## **PLEASMONT SUBDIVISION, RESUBDIVISION OF LOTS 3, 4 & 5**

APPLICATION NUMBER 21 DATE January 6, 2005

APPLICANT Pleasmont Subdivision, Resubdivision of Lots 3, 4 & 5

REQUEST Subdivision

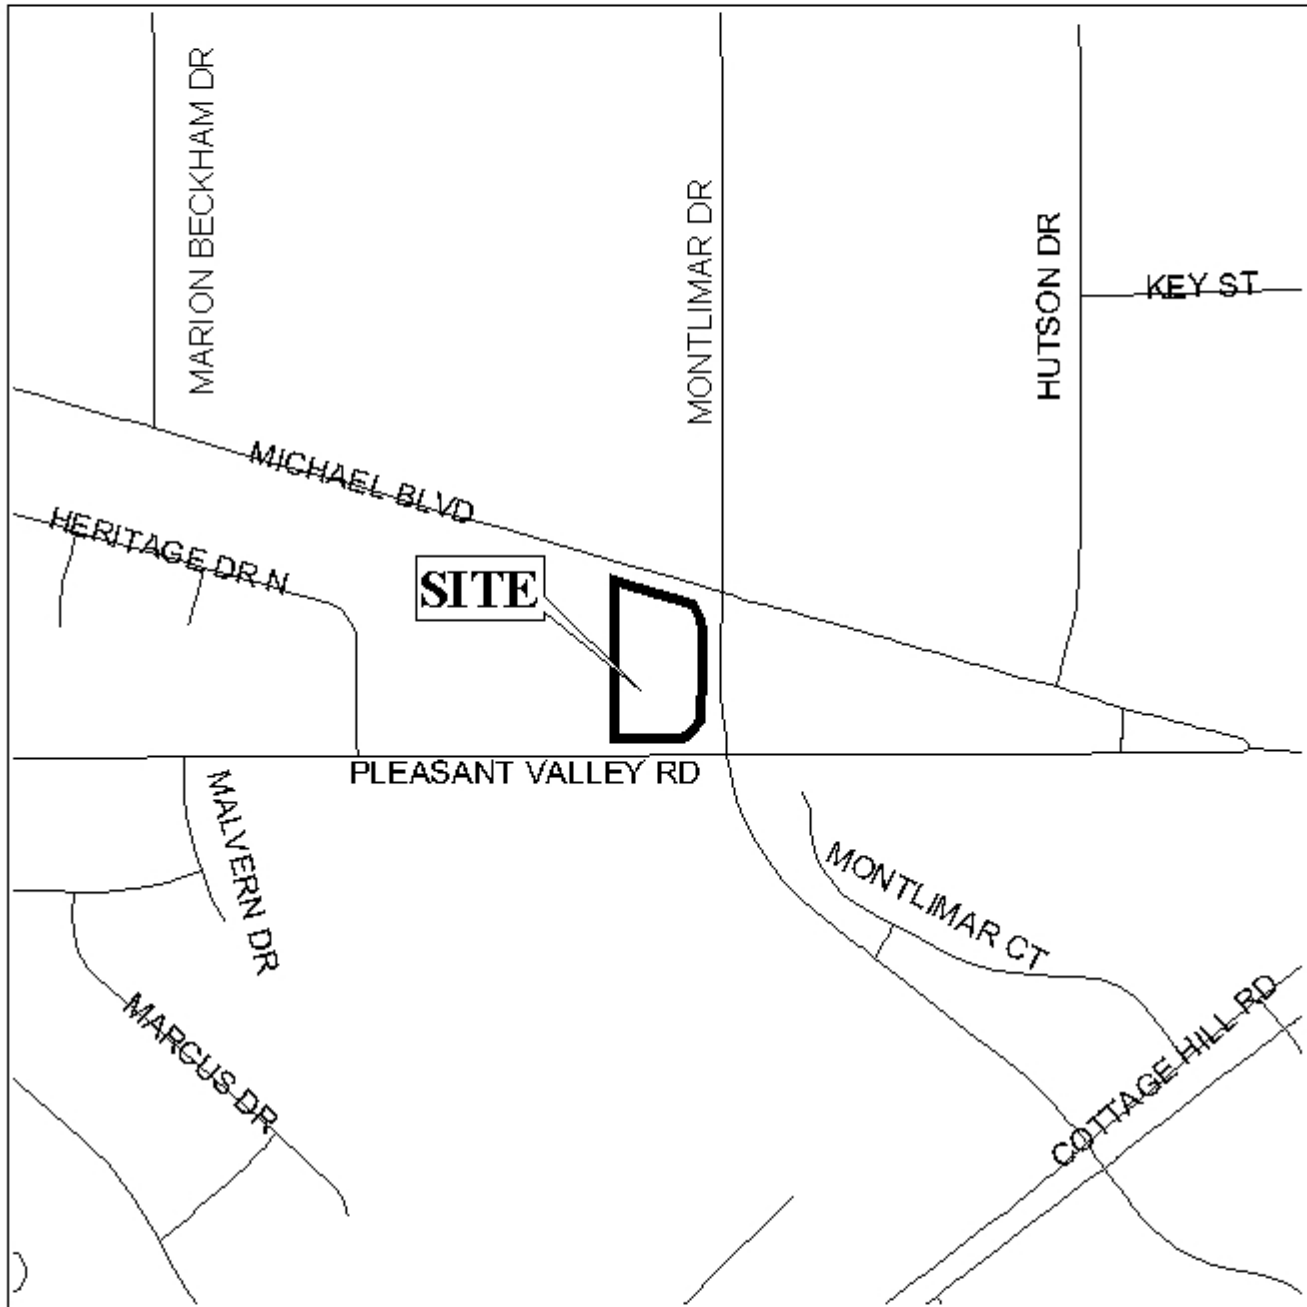
Engineering Comments: Must comply with all stormwater and flood control ordinances. Any work performed in the right-of-way will require a right-of-way permit.

Traffic Engineering Comments: Driveway numbers, size, location and design to be approved by Traffic Engineering and conform to AASHTO standards.

Urban Forestry Comments: Property to be developed in compliance with state and local laws that pertain to tree preservation and protection on both city and private properties (State Act 61-929 and City Code Chapters 57 and 64).

Montlimar Creek flows through the site and as such the area may be environmentally sensitive; therefore, the approval of all applicable federal, state and local agencies would be required prior to the issuance of any permits.

The plat meets the minimum requirements of the Subdivision Regulations and is recommended for Tentative Approval subject to the following condition: 1) the approval of all applicable federal, state and local agencies prior to the issuance of any permits.
